Mitsubishi Motors North America, Inc.

Mitsubishi Motors North America, Inc. (MMNA) submits this letter pursuant to 49 C.F.R. Part 579.12 – Foreign Recalls. Mitsubishi Motors Corporation (MMC) has advised us that certain 2007-2010 Lancer Evolution vehicles manufactured and distributed in Japan are subject to a safety recall campaign involving the clutch master cylinder. The clip securing the oil pressure pipe to the clutch master cylinder is insufficient and may become damaged due to oil pressure during clutch operation. Due to this condition, the oil pressure pipe may come off and create an oil leak, so that the driver cannot operate the clutch. To correct this condition, a stronger clip will be installed at the oil pressure pipe.

VEHICLE SAFETY/POLLUTION RECALL CAMPAIGN IN JAPAN

CAMPAIGN No.	2499	DATE	April 8, 2010
MANUFACTURER	MITSUBISHI MOTORS CORPORATION		
DESCRIPTION OF DEFECT	SINCE THE STRENGTH OF THE CLIP AFFIXING THE OIL PRESSURE PIPE TO THE CLUTCH MASTER CYLINDER IS INSUFFICIENT, THE SUBJECT CLIP MAY GET DAMAGED DUE TO THE OIL PRESSURE IN THE CLUTCH OPERATION. DUE TO THIS CONDITION, THE SUBJECT PIPE MAY COME OFF RESULTING IN OIL LEAK SO THAT DRIVER CAN NOT OPERATE THE C

Detail of Modification

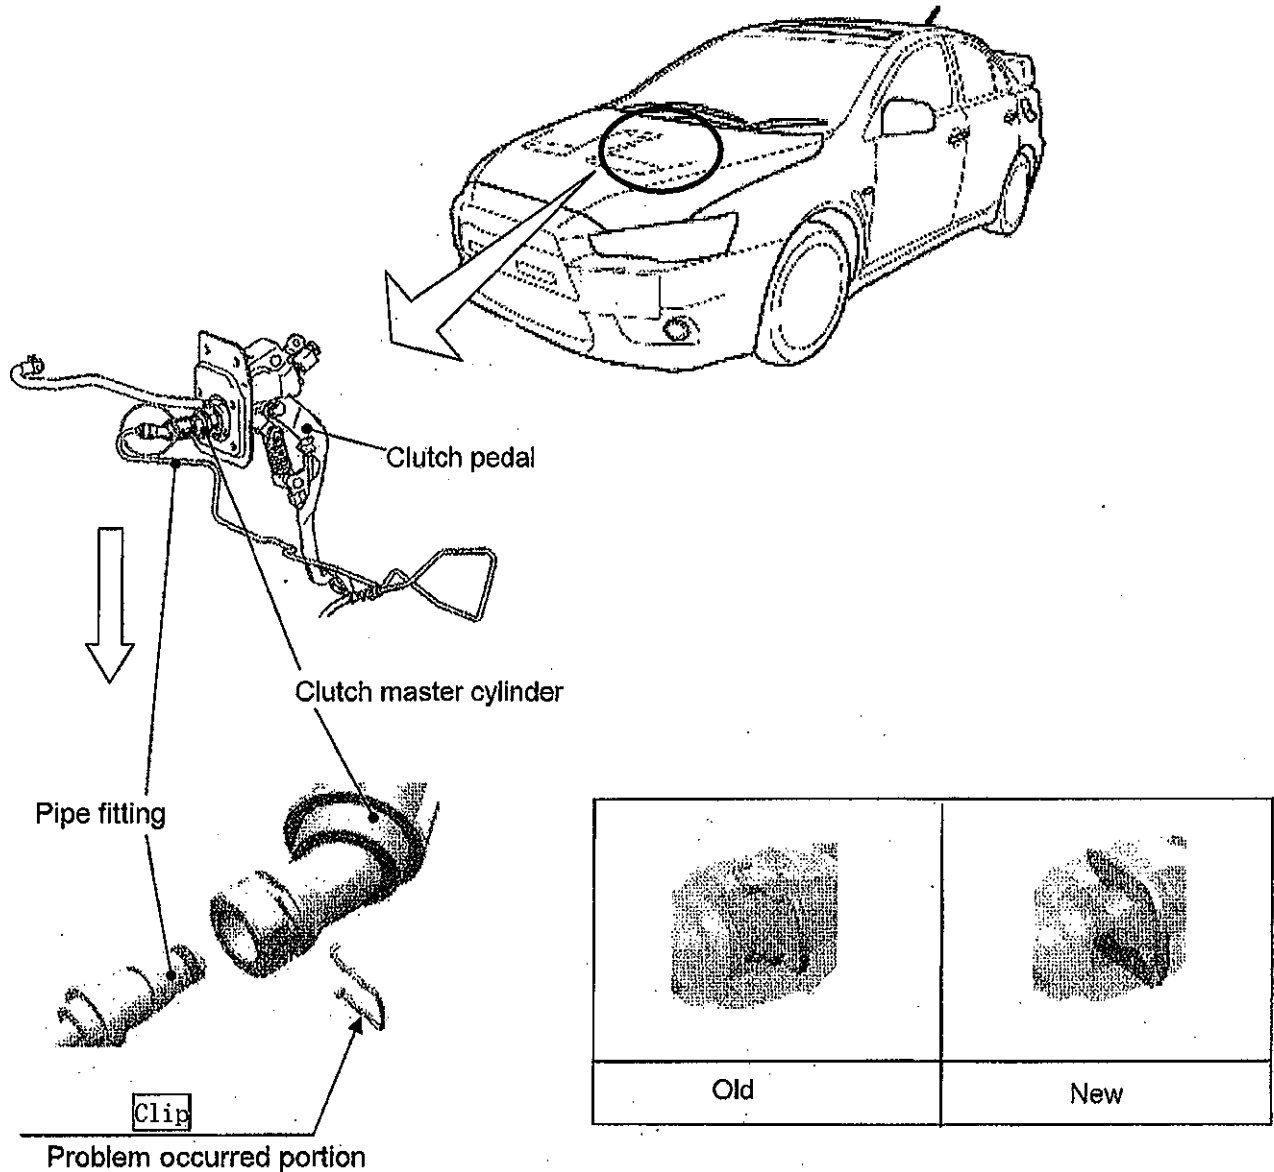
(Since the strength of the clip affixing the oil pressure pipe to the clutch master cylinder is insufficient, the subject clip may get damaged due to the oil pressure in the clutch operation. Due to this condition, the subject pipe may come off resulting in oil leak so that driver can not operate the clutch.)

Replace clip with countermeasure one

Note: In the above drawing, the part in the frame is the replaced one.

Identification: Apply paint mark (white or yellow) on the pipe fitting for clutch (near Clutch master cylinder).
